CITY OF AUSTIN  
APPLICATION TO BOARD OF ADJUSTMENT  
INTERPRETATIONS  
PART I: AGGRIEVED PARTY'S STATEMENT

C15-2011-0110  
TP-0125070317  
ROW-10659412

STREET ADDRESS: 3704 Bonnell Drive, Austin, TX 78731

We appeal the August 26, 2011 decision of Greg Guernsey of the Planning and Development Review Department to "approve for permit" the building plans for 3704 Bonnell Drive, attached as Exhibit Ex1; alleging error was made in the decision by an administrative official.

FRONT ELEVATION

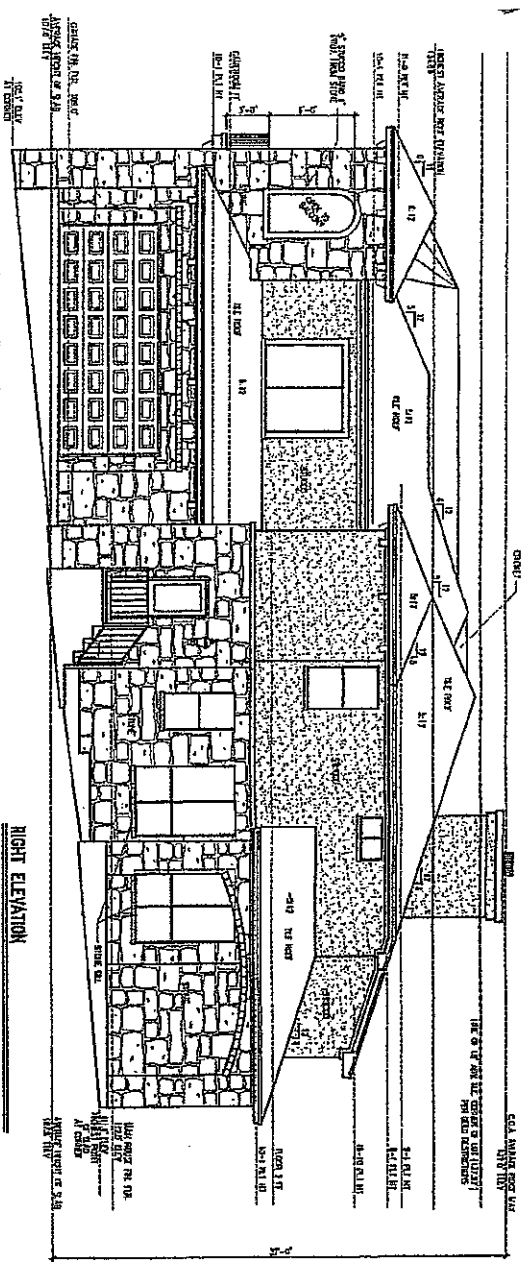
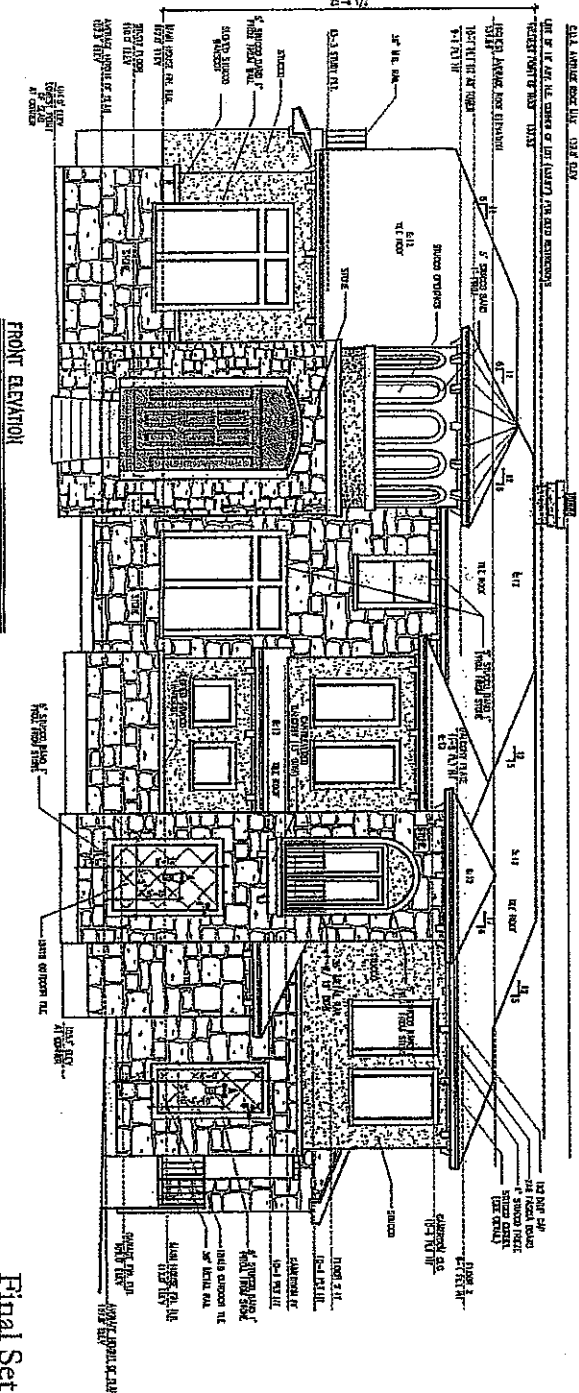
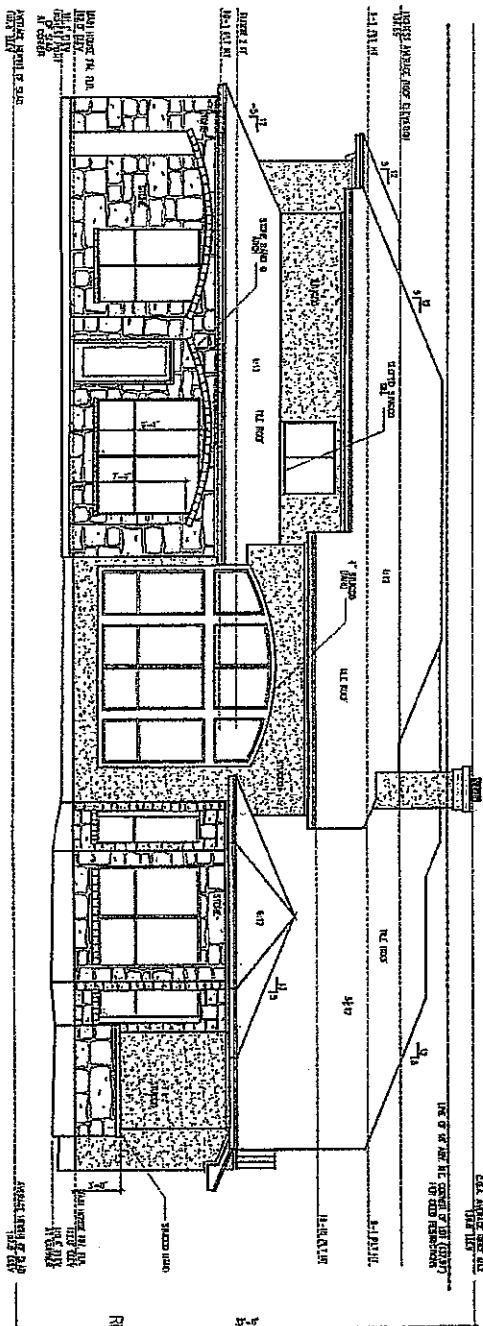
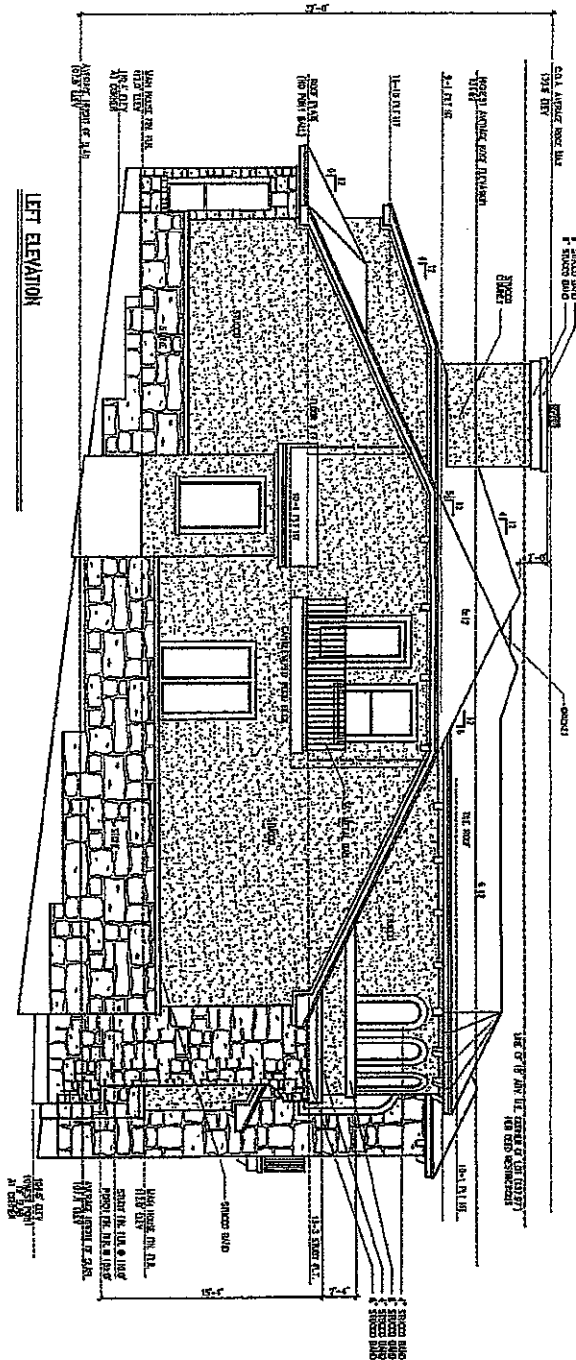
**Test number 1:** Visual inspection of the front and rear elevations of the house in attached Exhibit Ex0 reveals what appears to be a full two-story house. The roof ridge over the habitable attic space (left side of the front elevation) is about *18 inches below* the roof ridge over the main (central) portion of the house, and is about *18 inches above* the roof ridge over bedroom 3 (right side of the front elevation). (These measurements were made using large format to-scale plans.) This means a more detailed examination of the building plan is warranted.

# CENTRAL TEXAS ROOF PLAN

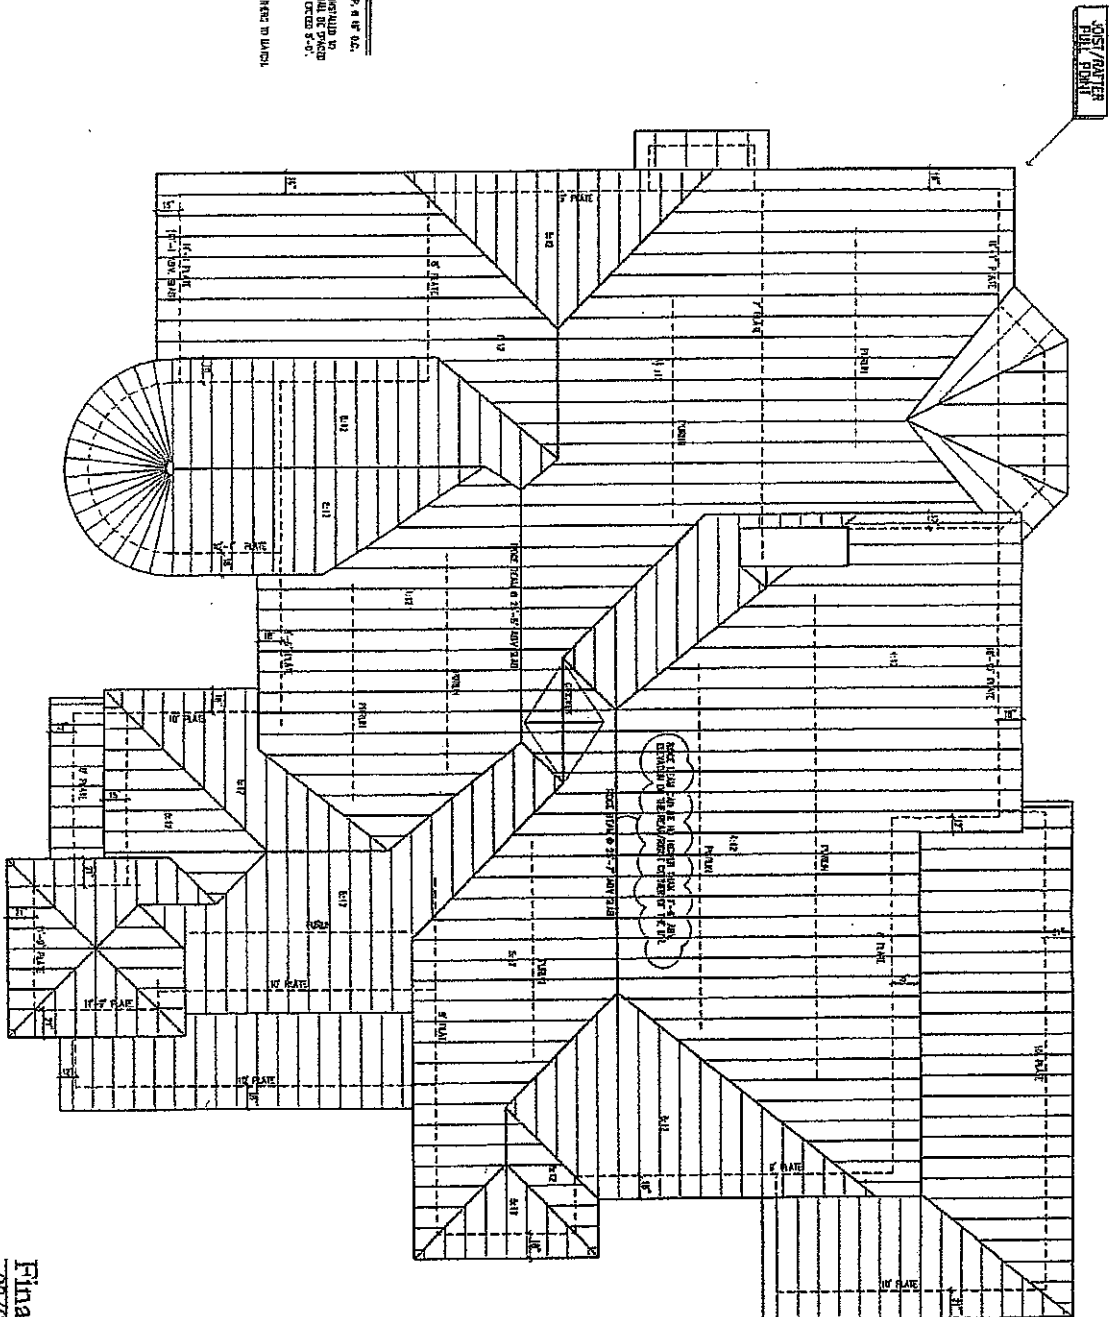
Application to proposed structure and the gable end attic under dispute: We examined the roof plan and floor layouts submitted with the application, focusing on sections of roof over the main living areas of the home and over the attic, noting the sections of roof that slope the same directions as the habitable attic roof. In both the front and rear of the house the slope of the habitable attic roof is greater (steeper) than the slope of the roof over the main living areas of the home. (Exhibits Ex24 and Ex25 show the Front and Rear roof plans and identify the roof slopes over different rooms in the house.) From this we conclude that the attic roof is built on a more massive scale than the roof over the rest of the house, and so the attic adds mass to the house.

How would the height of the attic roof change if the slope were reduced to match the slope of the attic over the main portions of the house? Using the large format to-scale elevations we determined that the ridge of the habitable attic roof is 13.5 feet above the finished floor of the attic. If the slope of the rear attic roof were reduced from its current 5.5 : 12 to match the 4 : 12 slope over the main living areas in the rear of the house (see rear slopes on Exhibit Ex25) its height would be only 9.8 feet ( $9.8 = 13.5 \times (4 / 5.5)$ ). That is, the ridge of the habitable attic roof would be 3.7 feet *lower* if the attic roof were built on the same scale as the attic over the main living areas of the house.

FAMILY ROOM HAS 20' CEILING  
FOYER HAS 22' CEILING

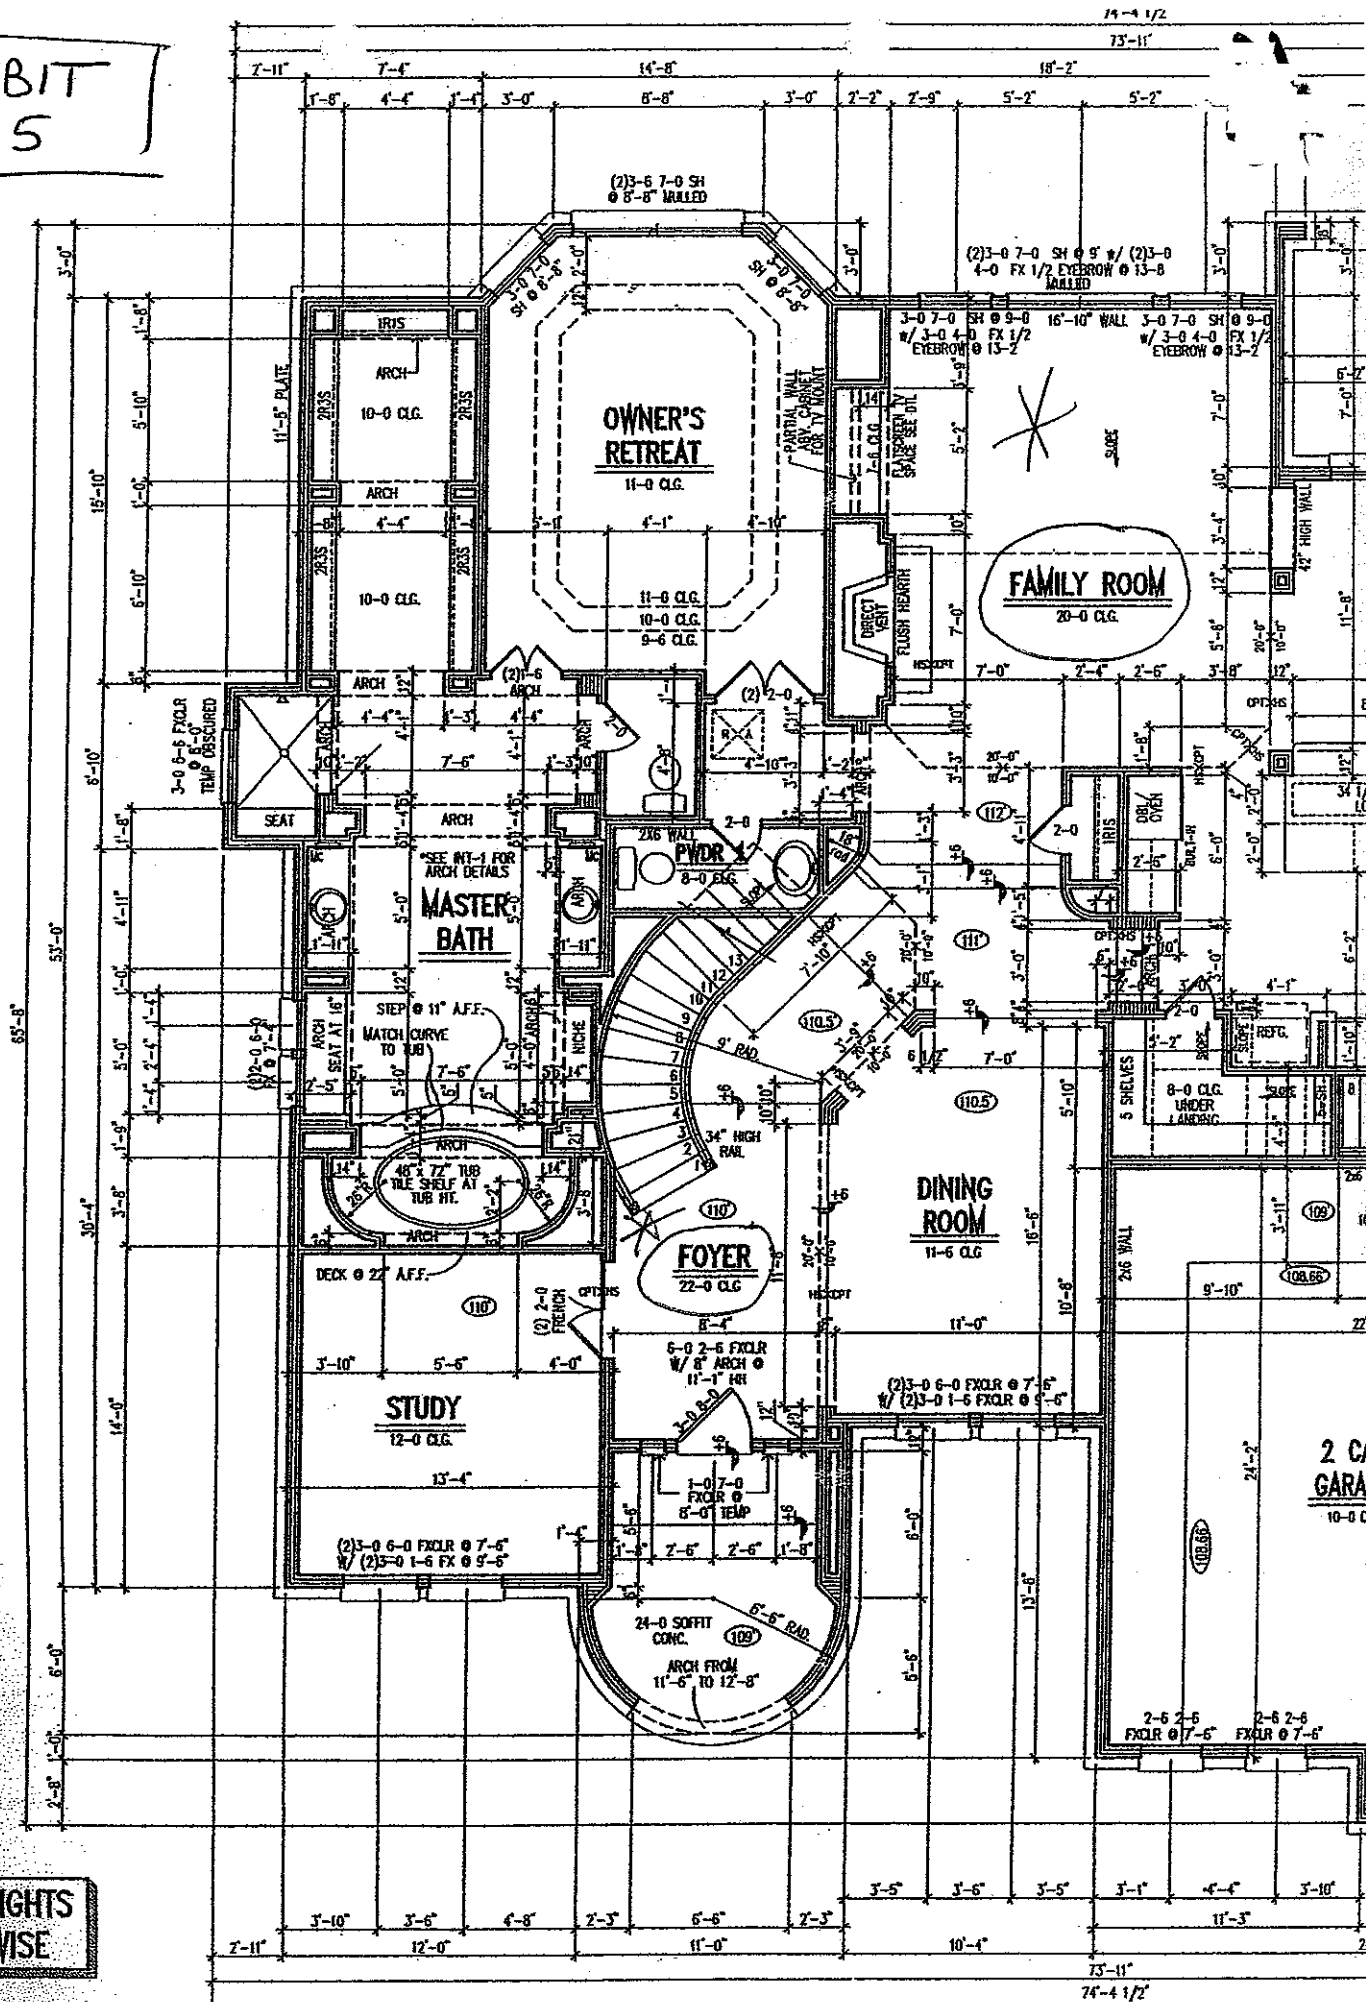
The plans submitted by the applicant show that the family room and foyer have ceiling heights between 20 and 22 feet (section of first floor layout showing this attached as Exhibit Ex5). Based on the dimensions shown on the plans, these areas have a combined floor area of at least 450 square feet. Properly double-counting these floor areas would increase the GFA from 4,537 to at least 4,987 square feet. This means the FAR would increase from 38.83% to at least 42.69% ( $4,987 / 11,683$ ), which exceeds 40% - the maximum amount of development permitted under Section 2.1 of the McMansion Ordinance.
